Pak Lay Hydroelectric Power Project

Regional Stakeholder Forums

12th June 2024

3. Addressing JAP Recommendation

Updated Key Feature – Fish Passing Facilities

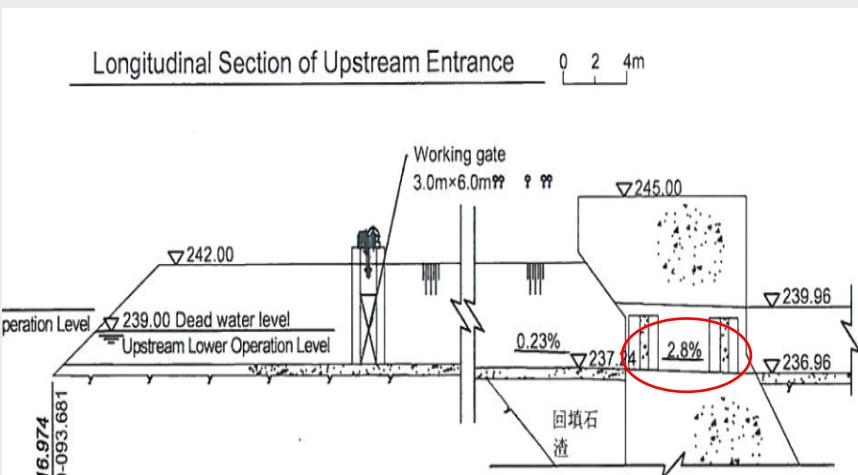
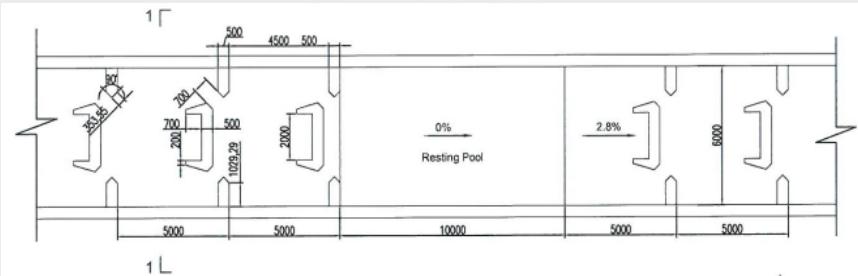
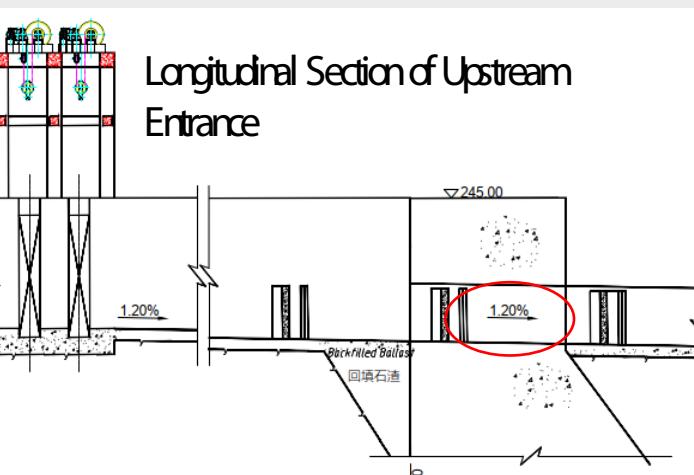
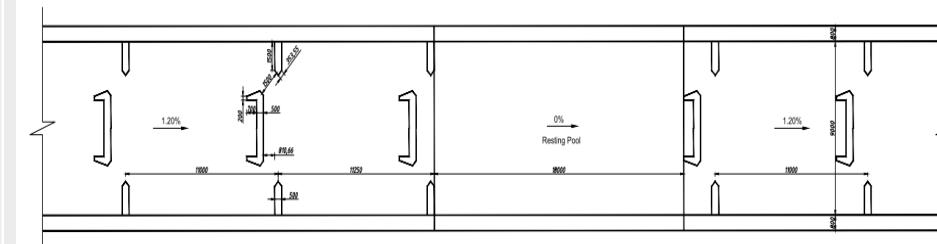
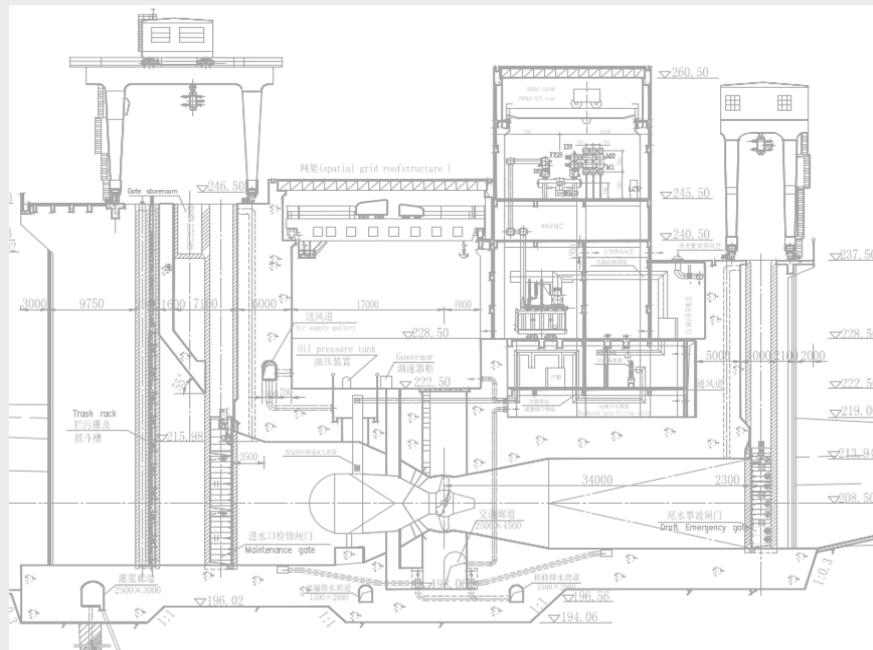
Key update

Redesign of the fishway layout to reduce its slope from 2.8% to 1.20%.

To meet the PDG 2023 on flow velocity and minimum water depth in fishway.

The Layout Structure of the Powerhouse-Fish Passing Facilities (FS)

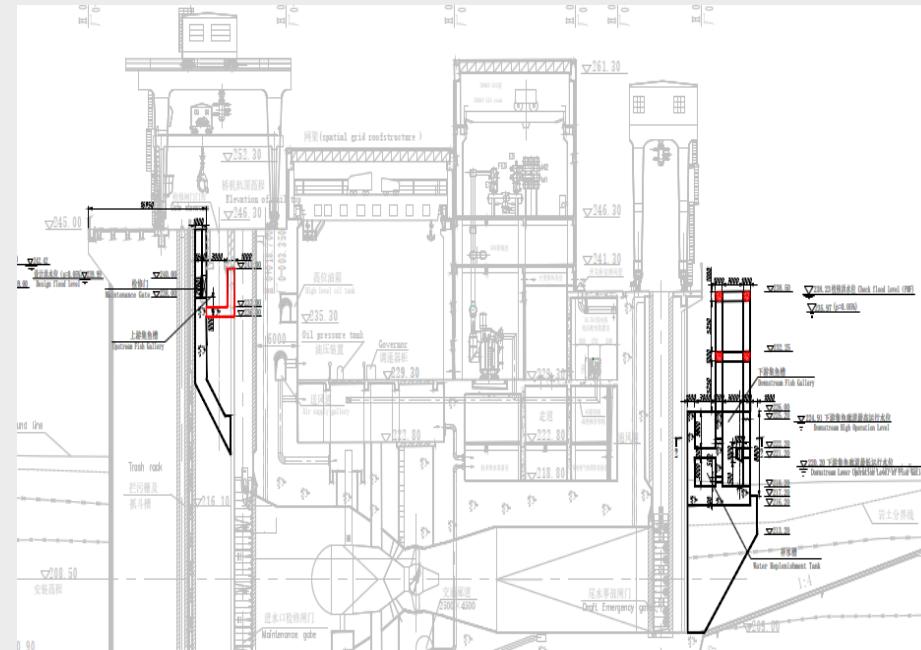
Key update

Update the design of the Powerhouse Fish Passing Facilities by adding Upstream and Downstream Fish Galleries.

To improve the system which fish can migrate on Powerhouse Section

Updated Key Feature – Turbine Type

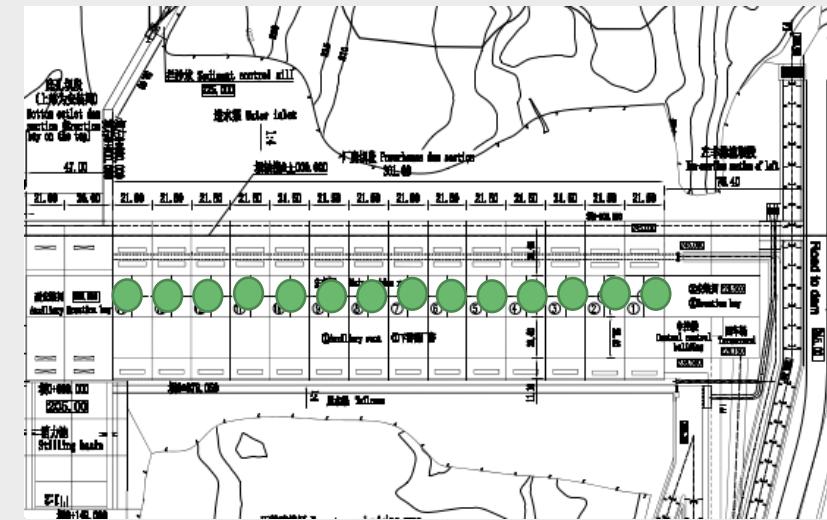
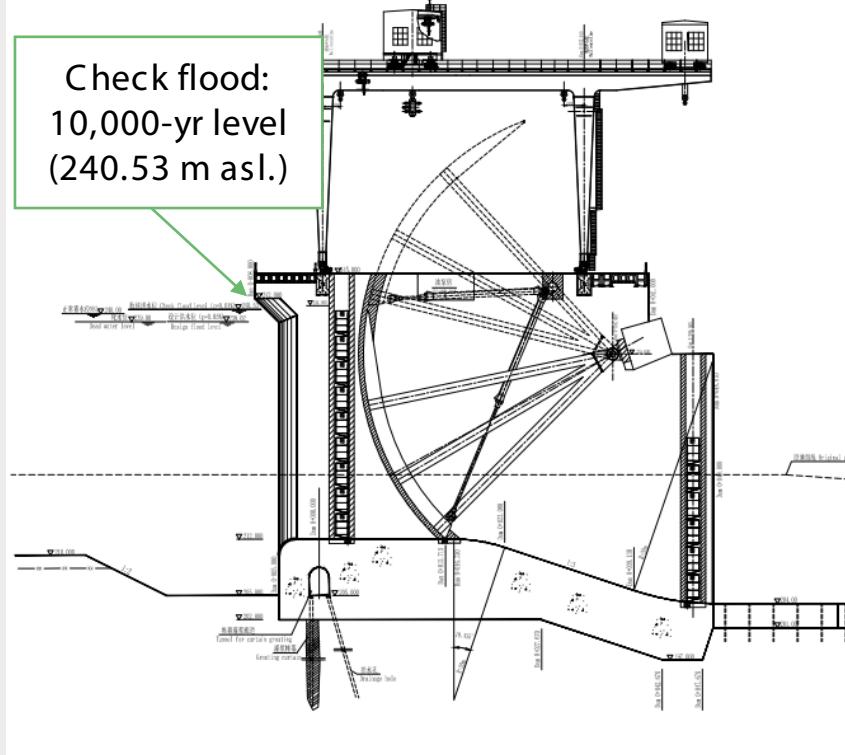
Key update

Redesign of the turbine 5
Blades @ 14 Units
To optimize the operation
and maintenance

The selected Bulb Type design is “fish-friendly”.

Updated Key Feature – Inflow Design Flood Criteria

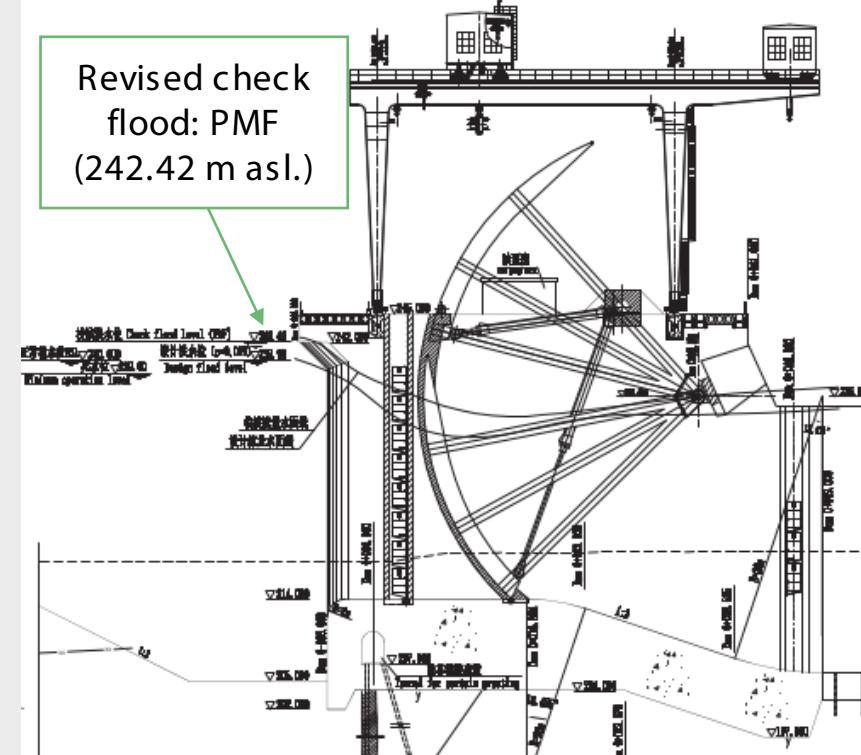
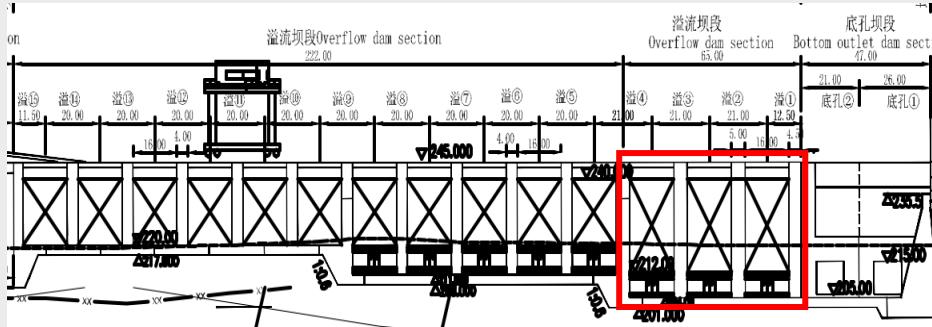
Key update

1. The Design Flood level

- Design flood level was kept at 2,000-yr return period.

2. The Check Flood level

- Check flood level was raised from 10,000-yr return period to the PMF

To comply with LEPTS2018 which still have freeboard around 2.58 m.

Updated Key Feature – Sediment Management System

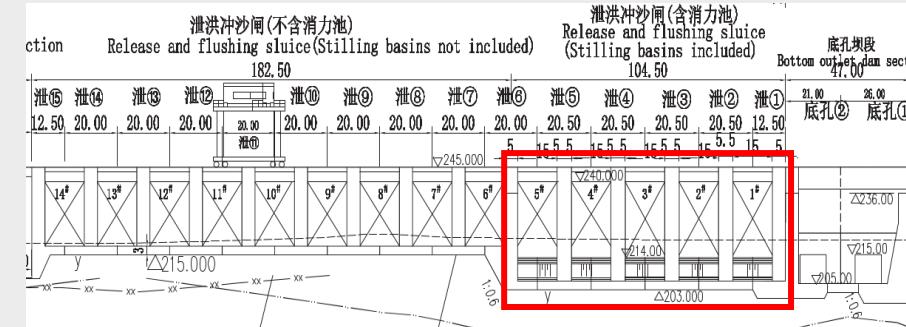
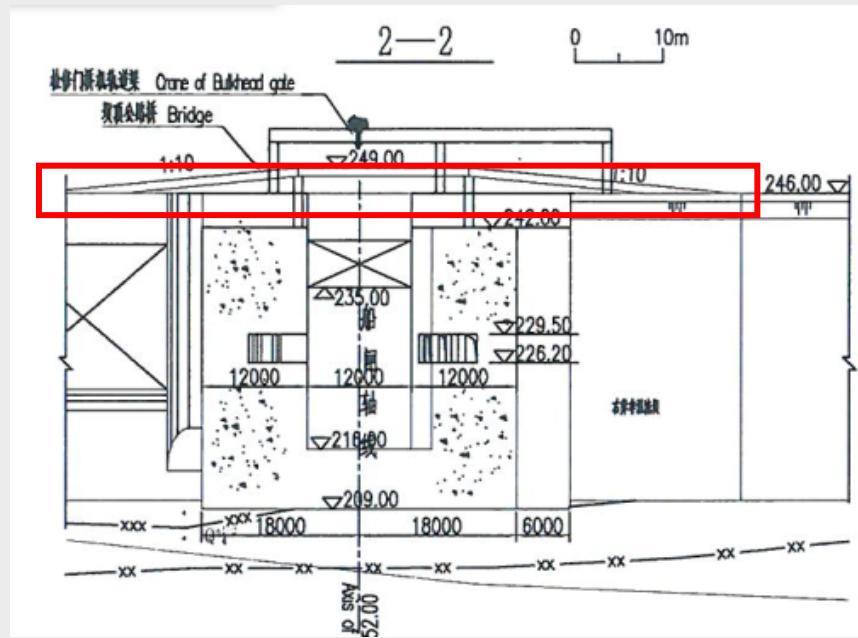
Key update

Release and flushing sluice :

1. The updated design increase the number of Deep Crest Spillway Outlets from 3 to 5 outlets
2. The bottom outlet dam section was kept as the same design

To increase the capacity for sediment management and release

Updated Key Feature – Navigation Lock

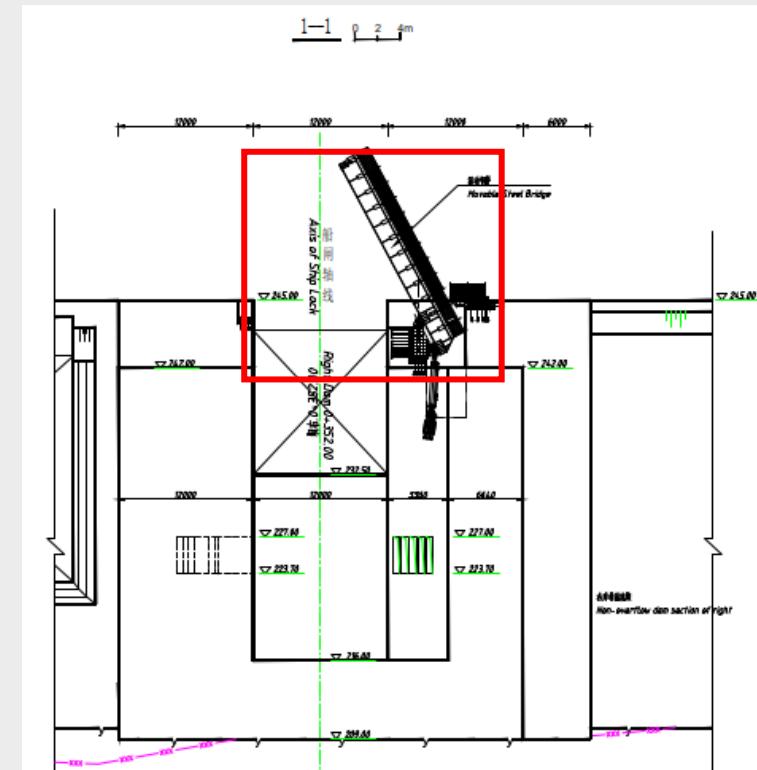
Key update

Update design to open bridge

Meet PDG 2023.

Optimizing sediment-related design to improve the sediment delivery efficiency.

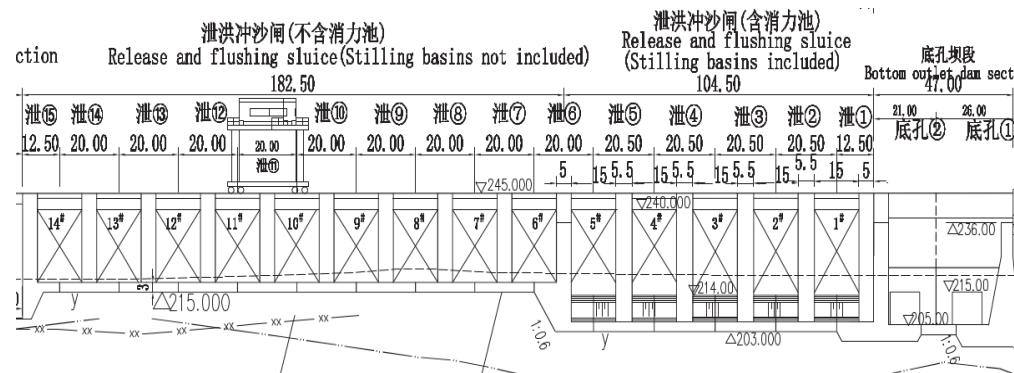
1. Design increase deep crest spillway outlet to 5.

Layout of Fishway Structure

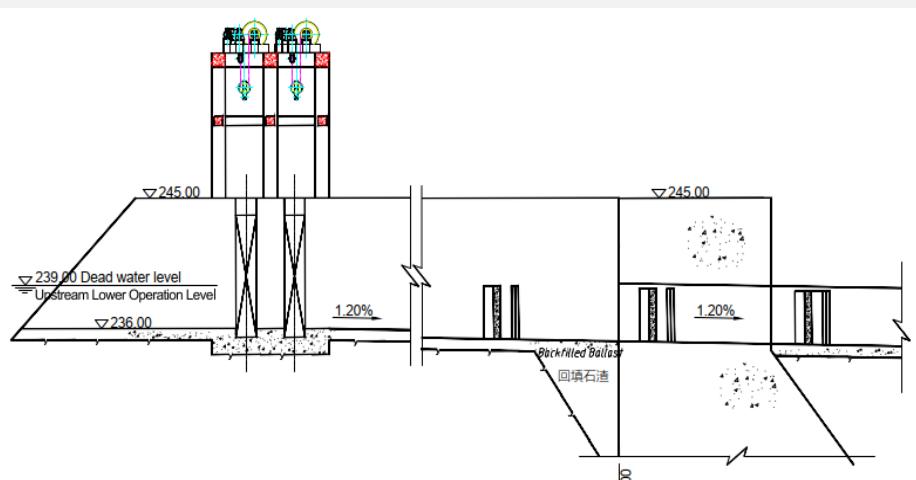
Key recommendation to improve performance:

- The upstream fish passage facilities
 - Reconfigure the downstream end to bring the entrance to the fish pass closer to the powerhouse tailrace.
 - Modify the collection gallery outlets.
- The downstream fish passage facilities
 - Reconfigure a number of deeper elevation inlets to increase opportunity for passage of midwater and benthic fish species.
 - Refigure the bottom end of the downstream fish pass to reduce the velocity at which fish enter the downstream river channel.
 - Reconfigure the fish pass at the upstream end to bring the exit nearer to the dam.

Using the lock system to facilitate fish migration during construction

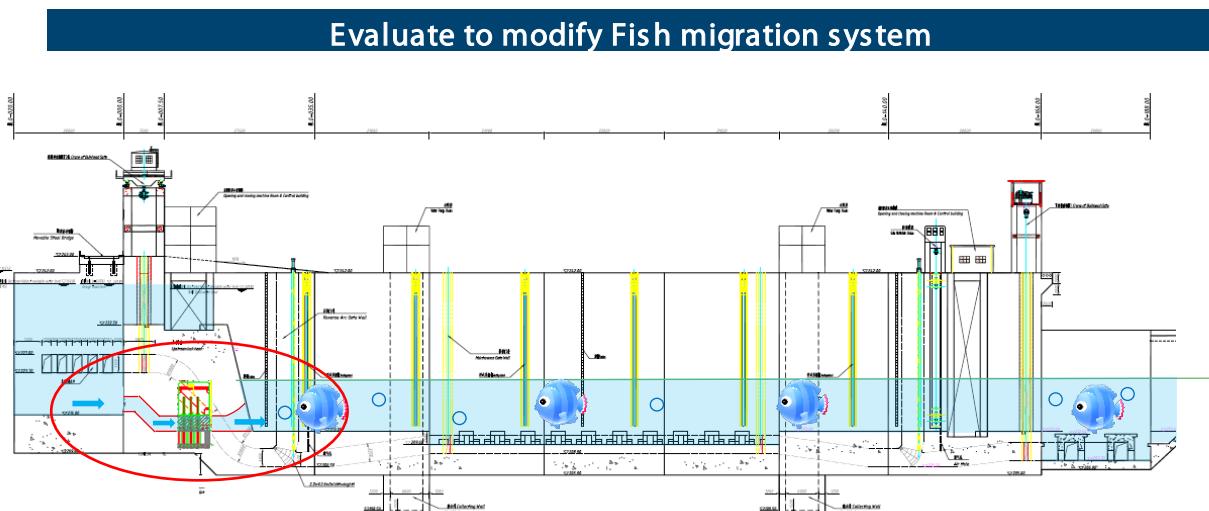
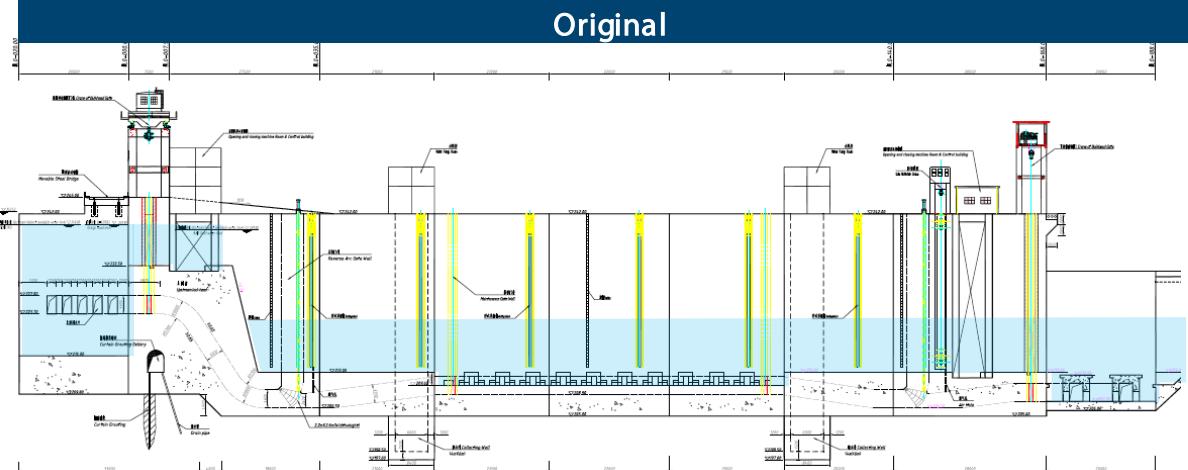
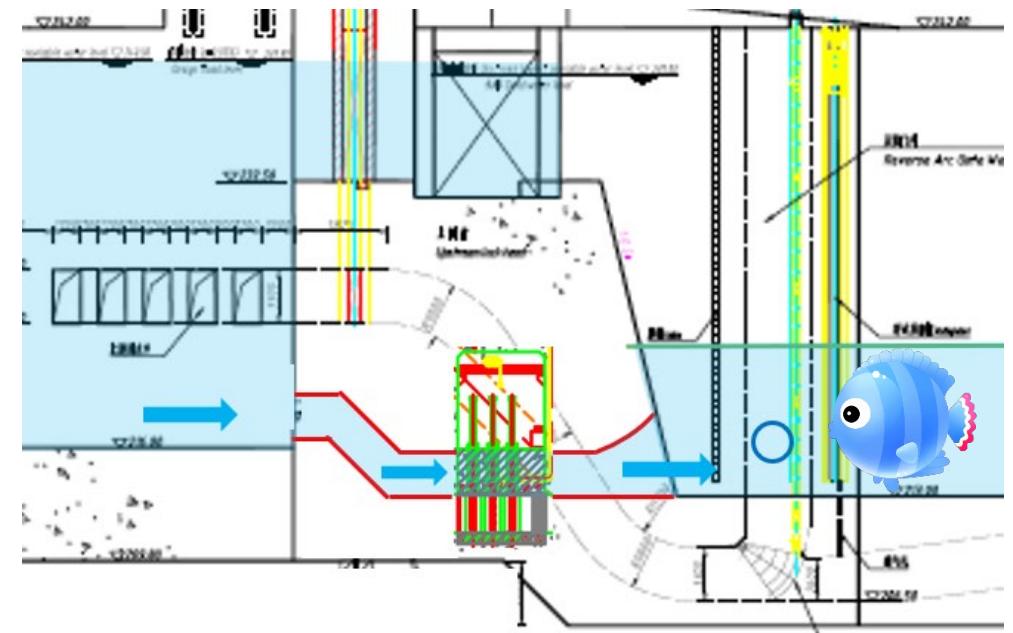
Additional flow to attract fish migration through the lock system during construction.

Under assessment to modify the lock system to facilitate fish migration during construction, drawing upon the Xayaburi system as an example.
